November 14, 2000

Office of the Secretary
Case Control Unit
STB Finance Docket No. 33407
Surface Transportation Board
1925 K Street NW
Washington, D.C. 20423-0001
Attn: Victoria Rutson

The Mankato Flood Wall. Possible Implications of Hydrostatic Pressure and Vibration from Intensive Rail Traffic

Floodwall at Section H-H at Depot (Station 86+50)

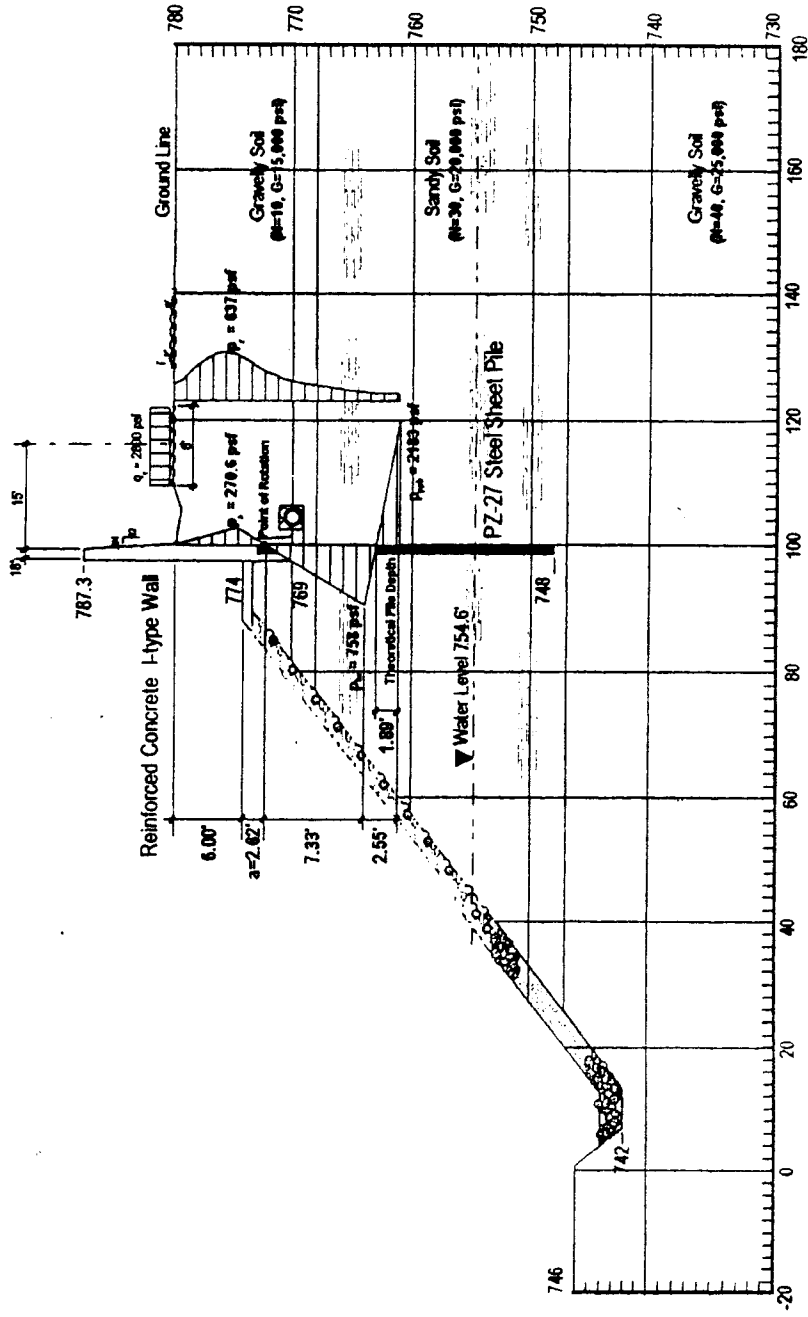
water level likelihood of one chance in three hundred (1:300). For the purposes of this document (see fig. 1), a "typical section" will be the depot site of floodwall section H-H. The typical elevation of 786.3ft at the top of the floodwall is the elevation of the wall at Main St.

This section of the floodwall is built on unconsolidated fill some seventy feet 70' above the bedrock but is not mounted or supported by piers or pilings. The fill material that supports the wall at the ground line on the inside or "city" side of the wall is mostly excavated soil, rock, debris and construction or demolition detritus that was excavated from buildings and basements from the pre-turn of the century era of construction in Mankato. This detritus is unconsolidated fill, which was placed along the riverbank to narrow the channel of the river at the point where the Minnesota River begins to swing to the north. Much of this backfilling effort was implemented to make way for the depot, railroad tracks and switching yards located there. In concert with this narrowing of the river the expanse of the "old Main St. Bridge spanning the river to North Mankato was foreshortened. No dynamic seismic and in-field dynamic soil tests have been conducted; there is no "real data" to determine the unconsolidated fill's true physical characteristics. The only data submitted to date has been based on "assumed" and static data for the site.¹

This untested fill, not just for the depot site but along the entire flood wall as it parallels the alignment of the railroad, has the very serious potential of failing as adequate structural support. It could also jeopardize either the integrity of the wall structure itself or the sub fill under

and on either side of the sheet pilings driven down to the 748ft level below the wall. The materials are in all likelihood gravelly sands, gravel soil or sandy soils.

Materials such as these, under the stress of hyper saturation during flood conditions with the river at a one hundred year flood level creating a column of water some 30 feet high, would undergo extreme pressures which would exceed 2000psf. With the harmonic vibration of railroad cars numbering upwards to one hundred fifty units each loaded with 30+ tons of coal and pulled by as many as five 40 ton locomotives traveling at thirty five to forty five miles per hour every 45 minutes day an night the pressure acting upon the unconsolidated materials in concert with the harmonic vibration could create the scene for a terrible disaster. Such an event could terminate in the loss of not only huge investments in both public and private properties but could result in loss of life from inundation or from disease infiltrating into the service infrastructure of both sewer and water systems.

The City, the Corps of Engineers and the Surface Transportation Board must give serious consideration to the possible consequences of giving permit to the D.M.&E for its proposed rail corridor through Mankato. Serious testing of the wall, its support structures and the associated land uses adjacent to the wall must be accomplished before any further consideration is given to “Alternative M-3.” Test borings, In-Hole Vane Shear Testing, In-situ Electronic resistance strain gauges or extensimeters should be used to

measure the deflection response of the sub grade and subsoil during train passages of 35 to 50 miles per hour. These tests need to be conducted during wet periods of the year, especially during spring break up. These tests also need to be conducted at times when river levels are high and with heavily loaded trains operating on the track or tracks. For optimal consideration there should be two trains running simultaneously as it will not be unusual to find two heavily-loaded trains operating simultaneously on adjacent roadbeds of both the D.M.&E and the Union Pacific Rail Roads. Furthermore these tests should be conducted as long term studies rather than a "once over lightly" or by a "walk through" analysis in the fashion of the leadership of the D.M.&E.

Map 1
Flood Insurance Rate Map, City of Mankato, MN., Federal Emergency Management Agency, Nov. 20, 2000

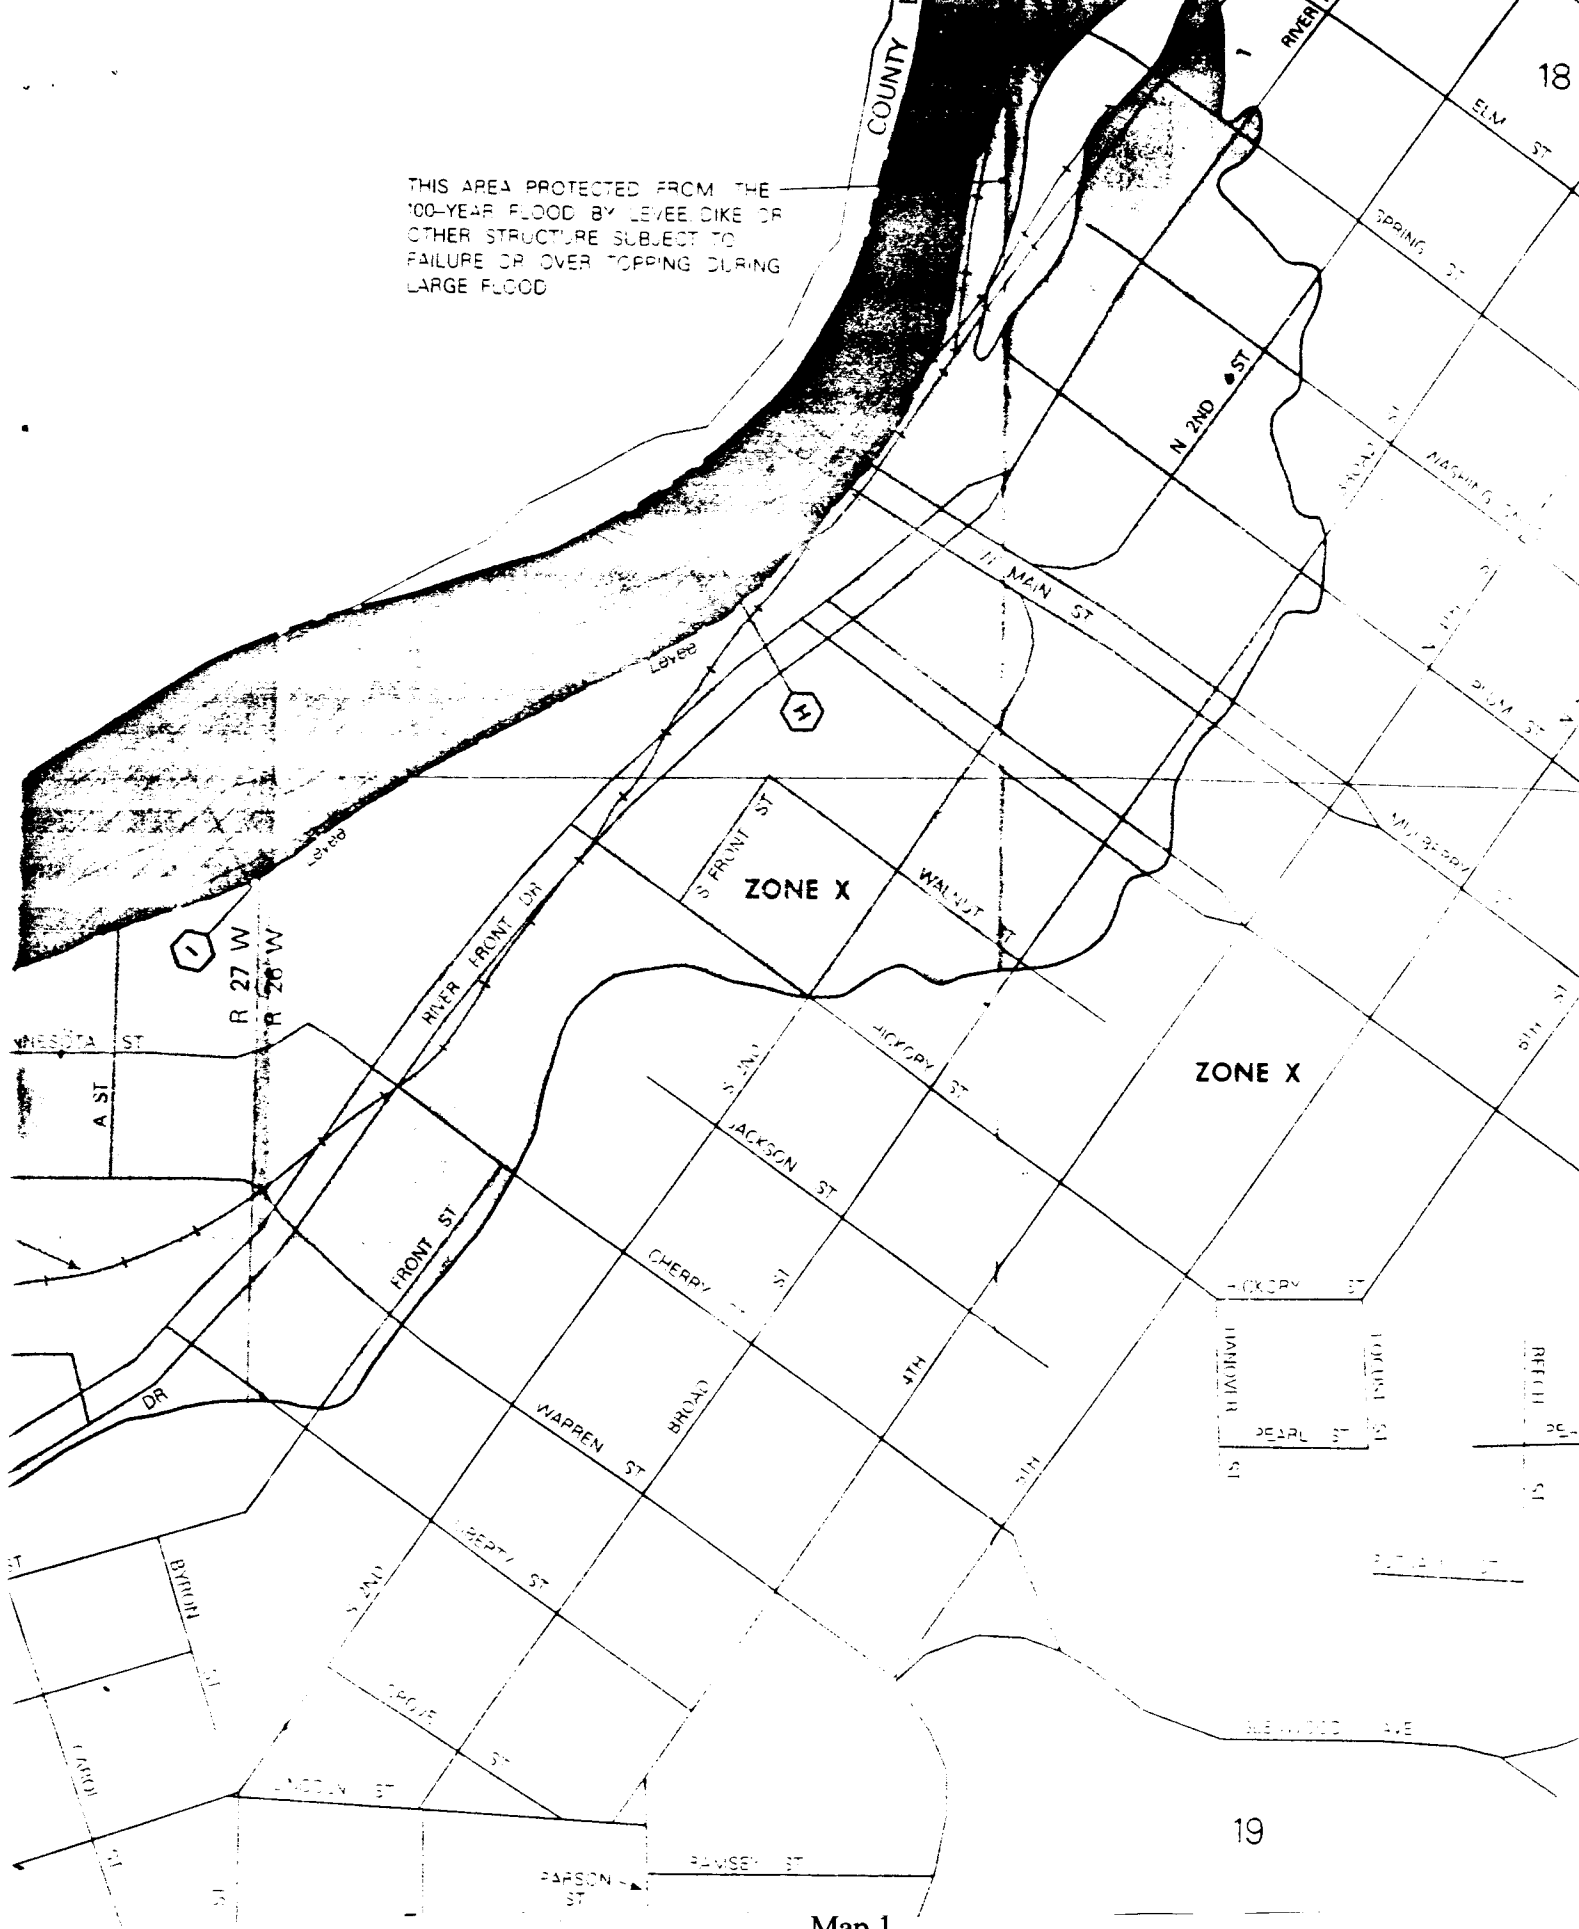
Such a "blowout" could weaken the subsoil and undermine the sheet pilings resulting in a loss of the structural integrity of the wall itself as the subsoil support is forced outward and upward along any zone of discontinuity. The explosive burst of water surging through the void it created would quickly flood the flood plain of much of "lower or downtown" Mankato. The extent of such flooding would be a function of the depth of the water in the river channel at the point of the "blowout" and the ability of emergency crews to intervene by quelling the water flow or the building of dikes to contain the flooding. (See Map 1)

hydrostatic pressure upon the wall while the base of the wall below the point of rotation would be forced “outward” or into the river. Were the structural integrity of a concrete section to be lost, a “wall” of water would literally surge into the city resulting in massive flooding along the river wall and levee back as far as Sibley Park and downstream to near the Mankato Stone Quarries at the base of Madison Avenue. (See Map 1)
